February 14, 2007

Husky's Response to Information Requests of EnCana dated February 7, 2007

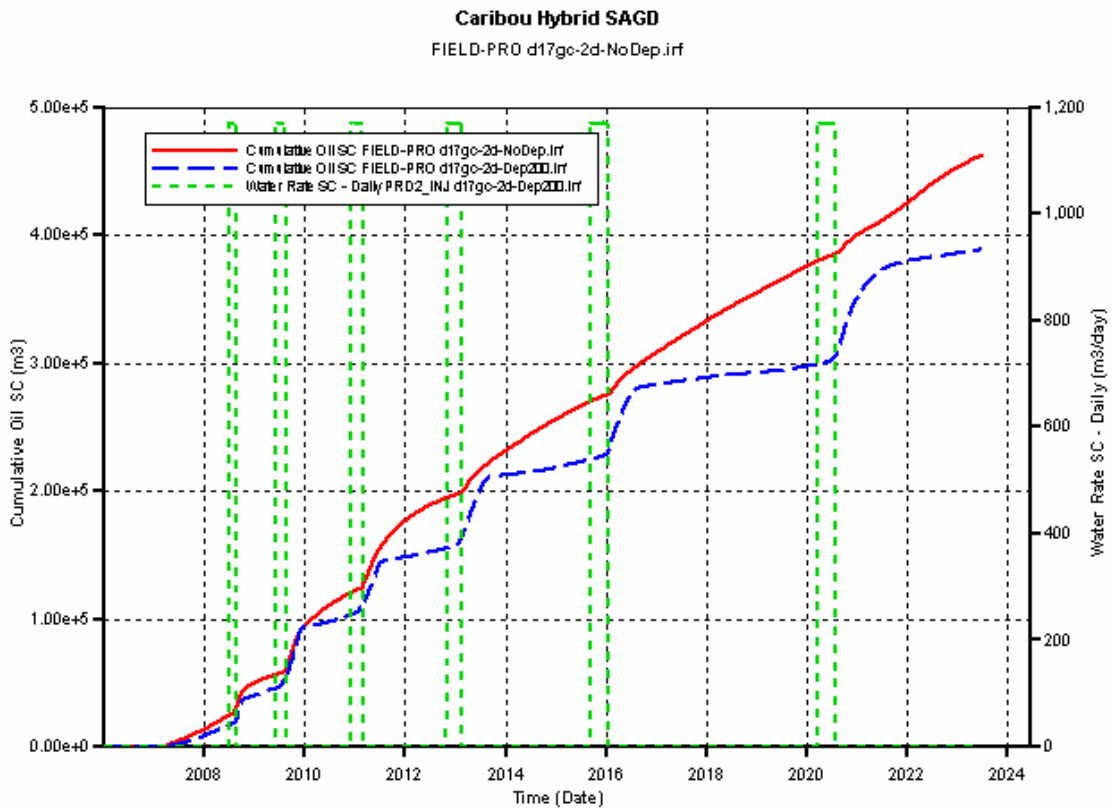
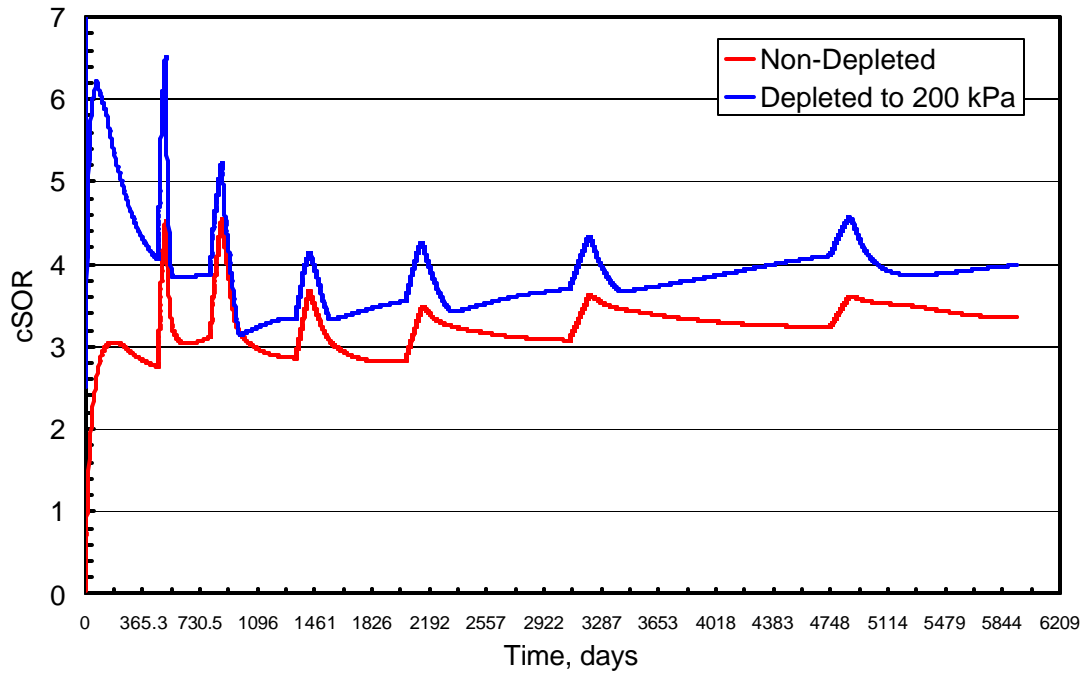
a. No maximum liquid production constraints were applied to the CSS and HSAGD producers, and

Liquid production constraints were not applied to HWCSS and HSAGD cases. Note that when such is the case, the same trends can still be observed with modified operating strategy. If the total liquid constraint is used and the CSS CDSR (calendar day steam rate) string is chosen incorrectly, then one consequence of the process performance is that the impact of solution gas drive on the process is suppressed. This means that the delta

between depleted and non-depleted cases is reduced but this is a total consequence of the chosen operating strategy where the delivery of oil to the wellbore by solution gas is suppressed.
